Cambridge – Local Planning Strategy – Draft 2018 -Submission

Annotated plans from Appendix 2

Figure 1 : Scenario-2018

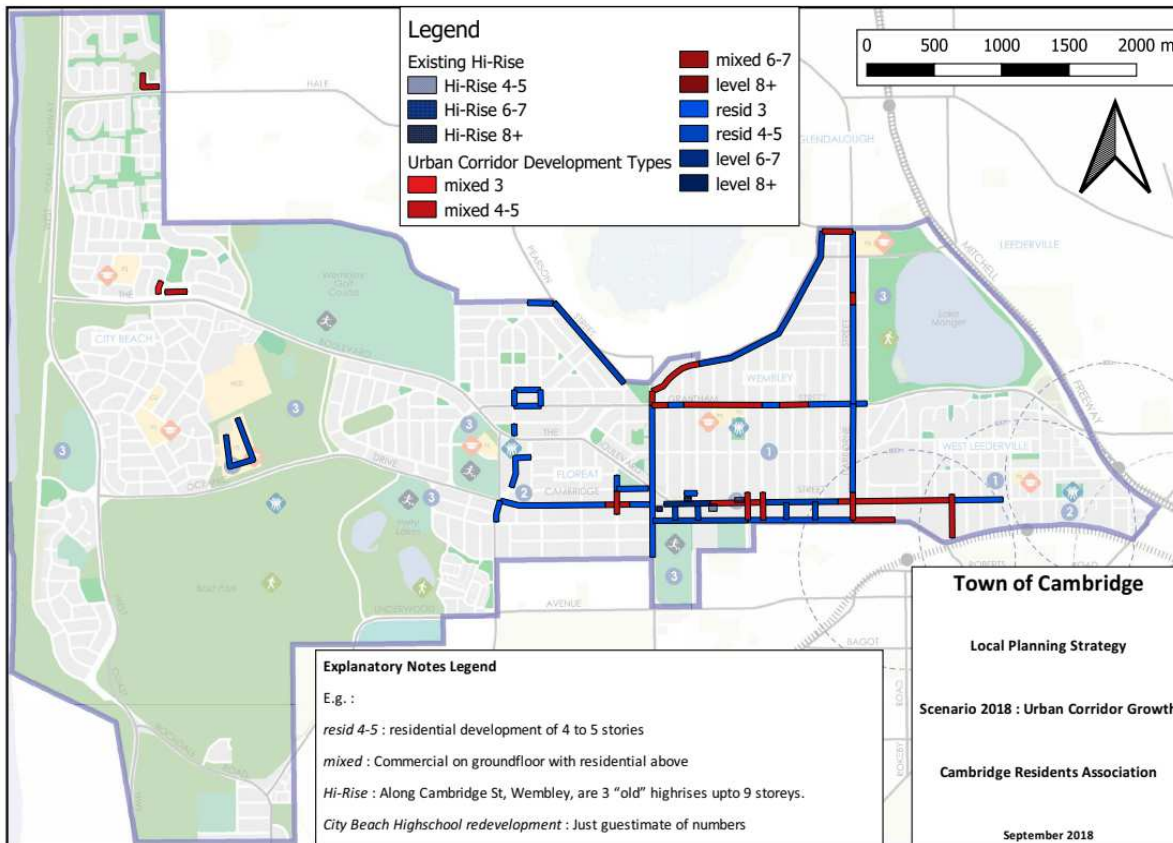
Figure 1 shows a map of an alternative proposal (**Scenario-2018**) where the density increase is mainly along main roads of Floreat and Wembley². So little increased density needed in West Leederville and some infill development in City Beach.

- The triangular green space between Selby-Cambridge and Boulevard to be kept a green space (needs re-landscaping, get rid of grass).
- part east of Selby St should be part of Cambridge-Wembley high rise precinct. The building on corner Selby and Cambridge is already 6 storeys high.
- On the west end why is urban corridor not extended on the northern side to Floreat Ave? And on the southern side extended westwards towards Brookdale and around the corner to Salvado.

SALVADO ROAD PRECINCT

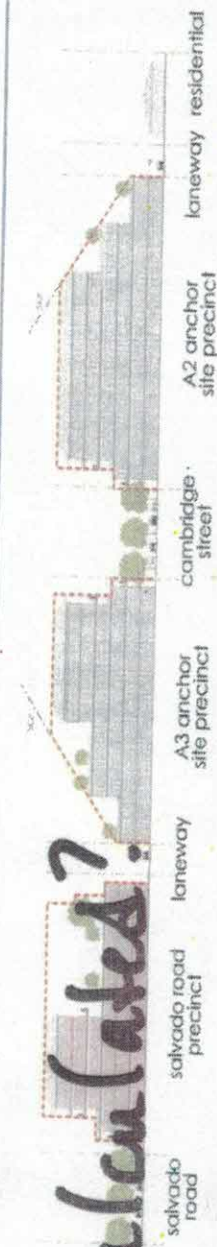
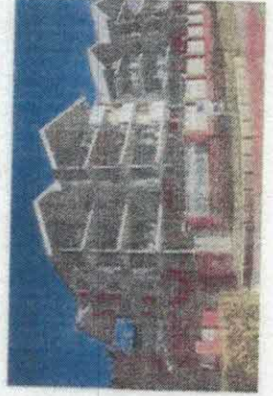
*Some are subject to Performance Criteria
What are they?*

How calculated?

ANCHOR SITE 2 & 3 *& everywhere else*

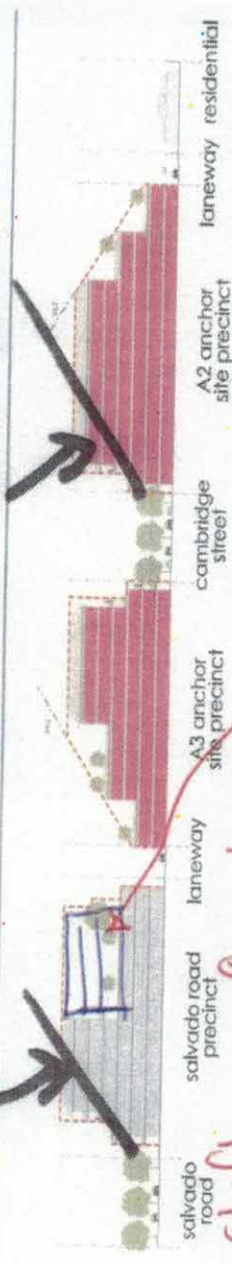
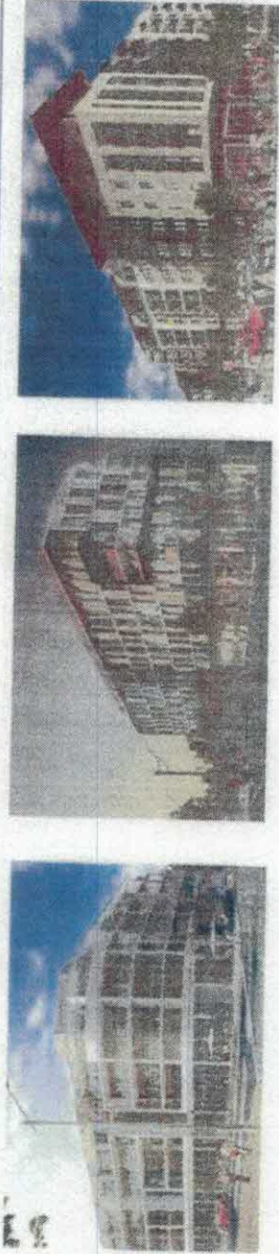
too steep creates too much shade in streets

Shift upper floors to here

URBAN CORRIDOR PRECINCT

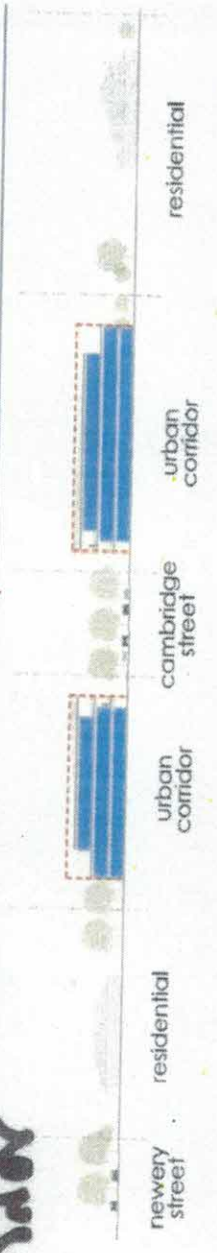
Extension Urban Corridor

SURPLUS GOVERNMENT SITES

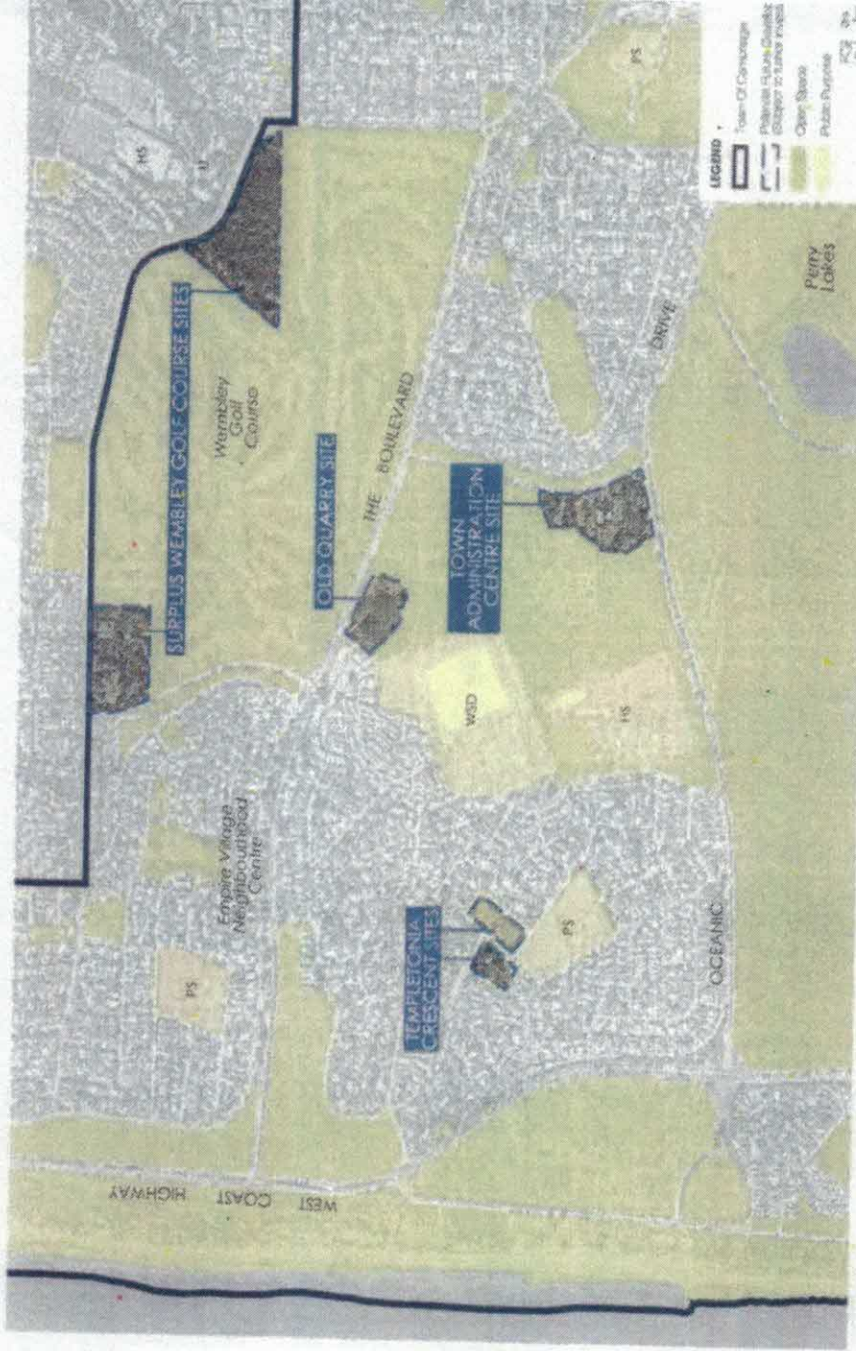
NO redevelopment Public Open Spaces.
